UNITED STATES PATENT AND TRADEMARK OFFICE

APPLICATION NO.	FILING DATE	FIRST NAMED INVENTOR	ATTORNEY DOCKET NO.	CONFIRMATION NO.
10/804,958	03/19/2004	Chanh C. Vo	HE0222	9176
21495 7590 06/15/2007 CORNING CABLE SYSTEMS LLC C/O CORNING INC., INTELLECTUAL PROPERTY DEPARTMENT SP-TI-3-1 CORNING, NY 14831				
			EXAMINER CHIEM, DINH D	
			ART UNIT 2883	PAPER NUMBER
			MAIL DATE 06/15/2007	DELIVERY MODE PAPER

Office Action Summary

DETAILED ACTION

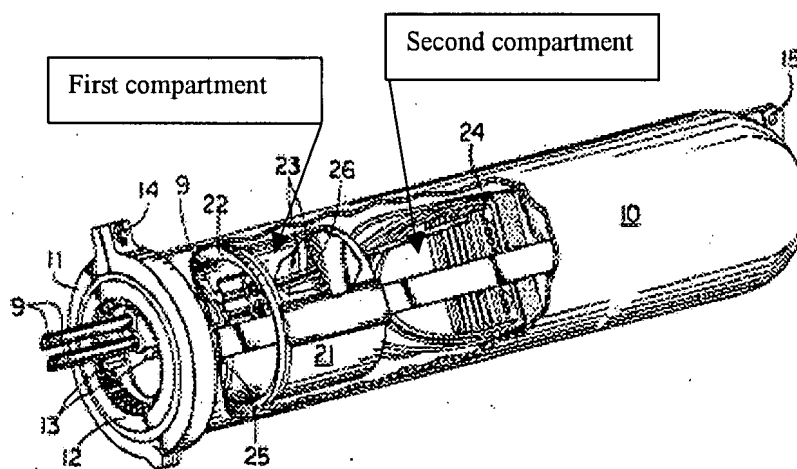
In terms of claims **1-4, 17, 20-21, and 28-29**, O'Neil teaches a splice pedestal comprising a base (Fig. 1; '12' '21' '24' and see also Fig. 7), a housing (10) positioned over the base, a distribution cable (9) received within the interior cavity, a plate (26) secured to one of the housing and the base and operable for separating the interior cavity into a first compartment (not explicitly drawn but explained in col. 2, lines 52-57) disposed within the housing and a second compartment (21). A splice tray (24), means for interconnecting. Furthermore, a plate (26) sealing the first compartment relative to the second compartment and the gel is only filled from (21) to (25), which is the first compartment and the second compartment is substantially free of a gel encapsulant material.

Regarding claims 8, 11-12, and 18-19 the “plate” is referred to as “circular areas” by O’Neill; wherein the circular areas joined together to form a plate sealing the first compartment relative to the second compartment. The second compartment creates a bell jar effect when the housing (10) is positioned over the base to further seal the interior cavity relative to the ambient atmosphere.

- Examiner has defined her consideration of the first and second compartment (see figure incorporated in rejection above). The first compartment extends from element 21 to 25 wherein plate 26 separates the first compartment from the second compartment. O'Neill teaches that the gel is filled from the portion of element 21 to 25, which is examiner's defined "first compartment". Thus, the second compartment is free of a gel encapsulant.
- O'Neill's prior art also reads upon the amended limitation of "wherein the interior cavity is substantially free of a gel encapsulant material." The second compartment (see the incorporated figure in the rejection above) is from element 26 to the end portion that is closer to the dome of the capsule is considered the "interior cavity."
